Remarks

Cunningham et al
Appl. No. 09/767,959

FIG. 12

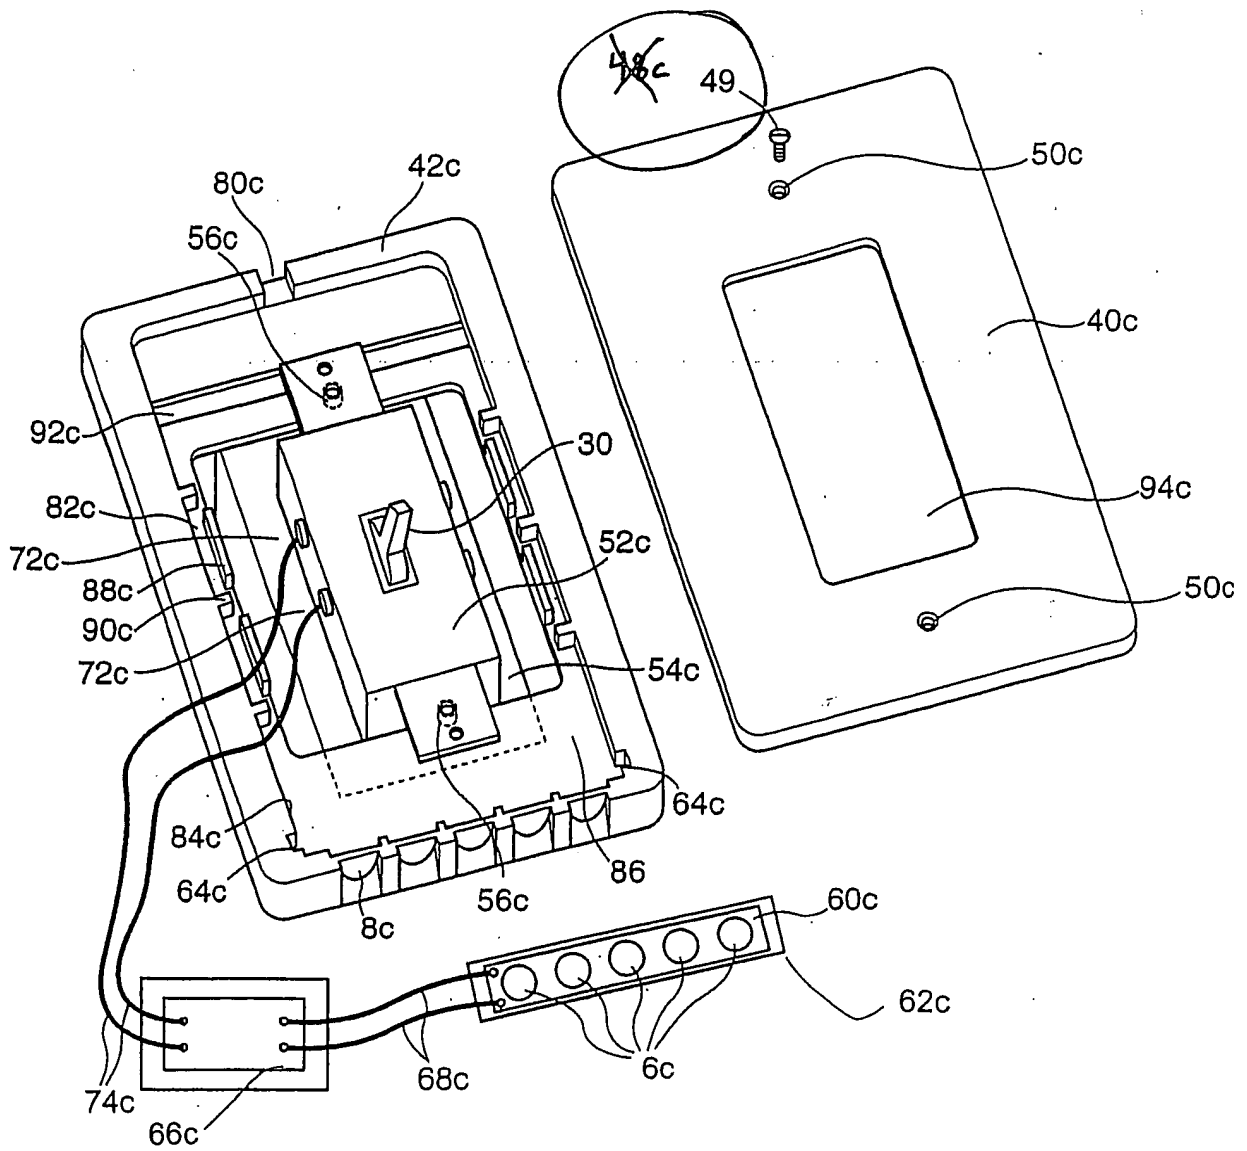
A proposed drawing correction to Fig. 12 is enclosed and highlighted in red. The correction replaces a reference numeral; so that, the drawing corresponds to the related text. No new matter has been added.

Cover 40c mounts on top of frame 42c, allowing access to switch 30 of light switch 52c through opening 94c. Apertures 50c on cover 40c align with screw holes 92c on light switch 52c. Screws -- [48c] 49 --, or other suitable fasteners, may be used to secure cover 40c -- [, frame 42c] -- and wall outlet 52c together.
